From: Hans Carstensen [carsthliii@worldnet.att.net]
Sent: Saturday, October 27, 2007 3:35 PM
To: Miller, Nick
Cc: Brian Hamilton
Subject: FW: Measurement Devices

I would be grateful if you would let me know at your earliest convenience if these drawings will meet the IDWR requirements for the S-41 and S-42 diversions off the Salmon River. Once I hear back from you, I will proceed to get these drawings into the hands of a competent fabricator.

UNITED STATES
 DEPARTMENT OF THE INTERIOR
 COLUMBIA RIVER TRIPPLE SALMON RECOVERY PROJECT
 UPPER SALMON RIVER BASIN - BASIN
 S-42
SALMON RIVER
RAMP FLUME
PLAN AND SECTIONS

ALWAYS THINK SAFETY	
<small>UNITED STATES DEPARTMENT OF THE INTERIOR COLUMBIA RIVER SALMON RECOVERY PROJECT UPPER SALMON RIVER GAIN - BAND S-41 SALMON RIVER RAMP FLUME PLAN AND SECTIONS</small>	
DESIGNED: JSL/hrs	DRAWN: Chris Bennett
DATE: 10/27/07	REV: APR. 08/10/07
APPROVAL: _____	DATE: _____
SCALE: AS SHOWN	1678-100-936

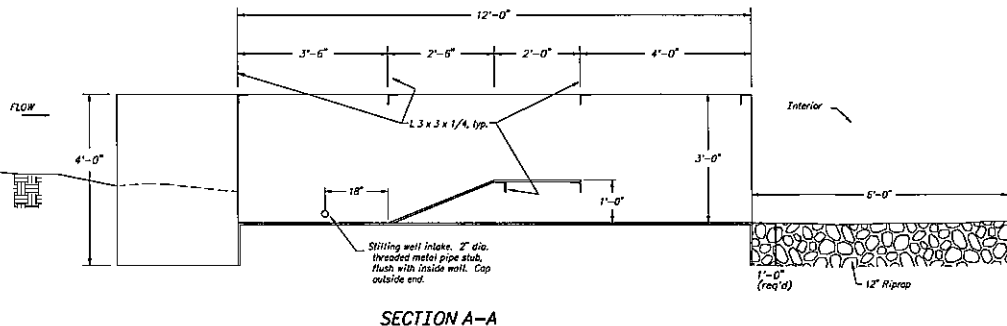
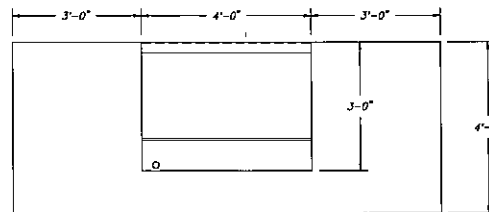
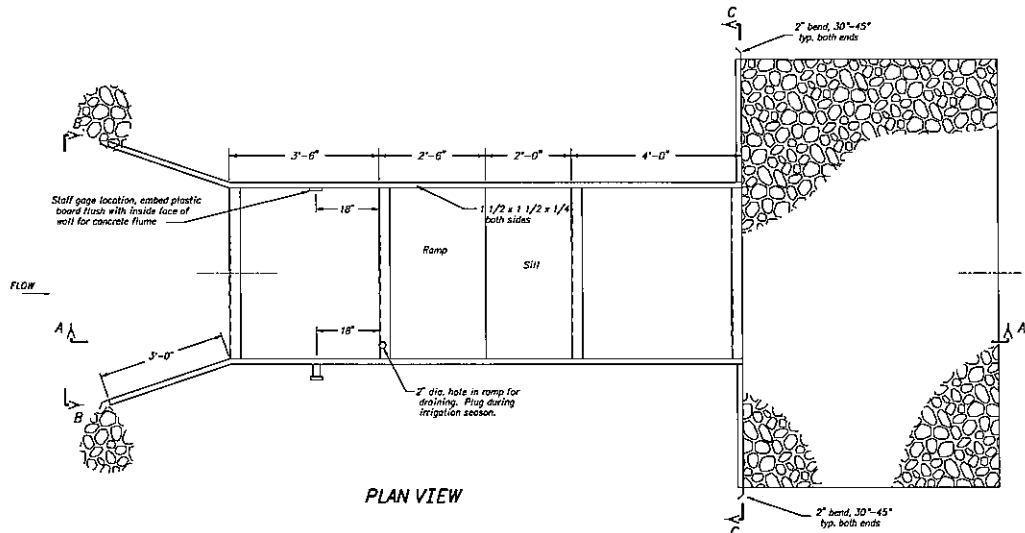
S-42 would need to be installed about 50 yards downstream from the fish screen. The willows growing into the ditch from the fish screen downstream 100 yards should be trimmed out of the ditch to allow this structure to function correctly.

These rights also bear a condition stating: "4.36 CFS OF RIGHT NO. 71-04037 IS LIMITED TO USE FOR CONVEYANCE LOSSES IN DELIVERY OF THIS RIGHT [71-2063] AND 71-04037". This means that Hans can divert up to 10.83 cfs at the head, but he may only receive 6.47 cfs at his field. So, depending on how close the MD is to the field, you may be able to design for a max flow as low as 6.47 (assuming he will want to take his entire right from one ditch at any time).

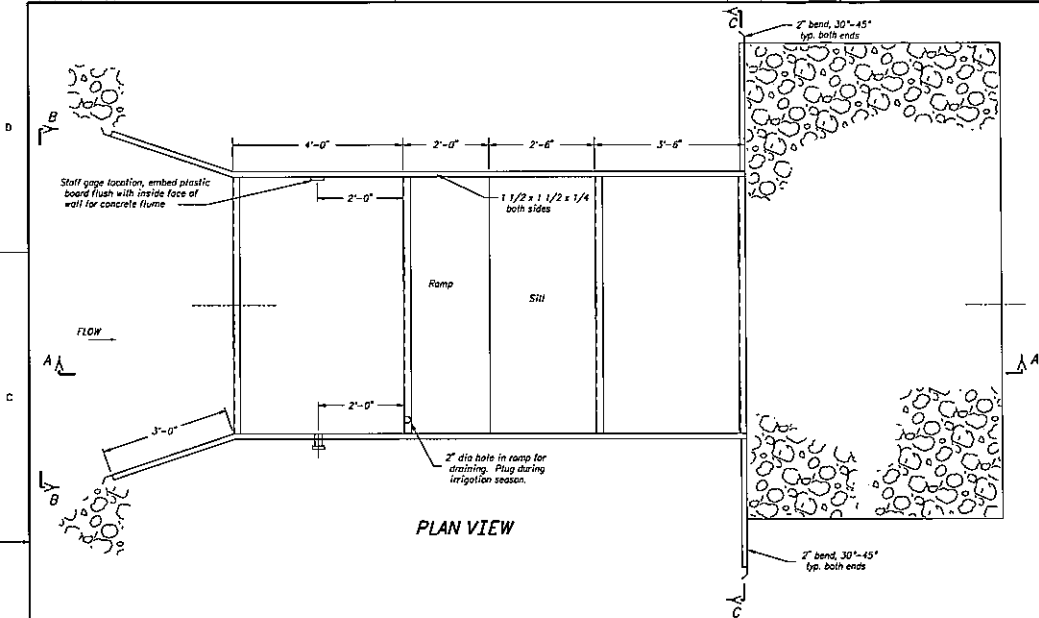
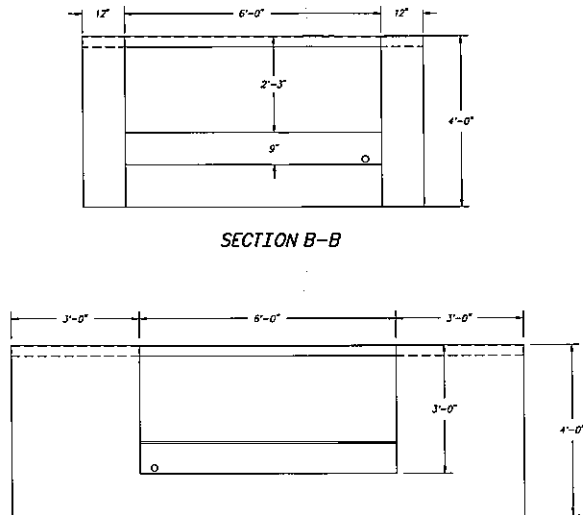
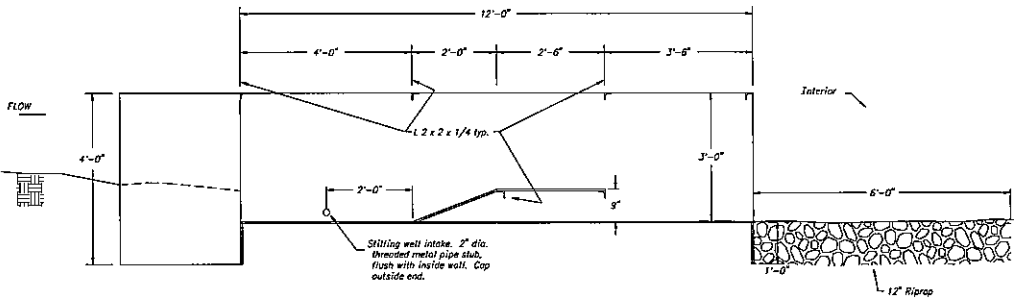
S-41 would need to be installed about 40 yards downstream from the headgate, which is above the fish screen. Allowances would need to be made to credit you with about 0.8 cfs for the fish screen bypass.
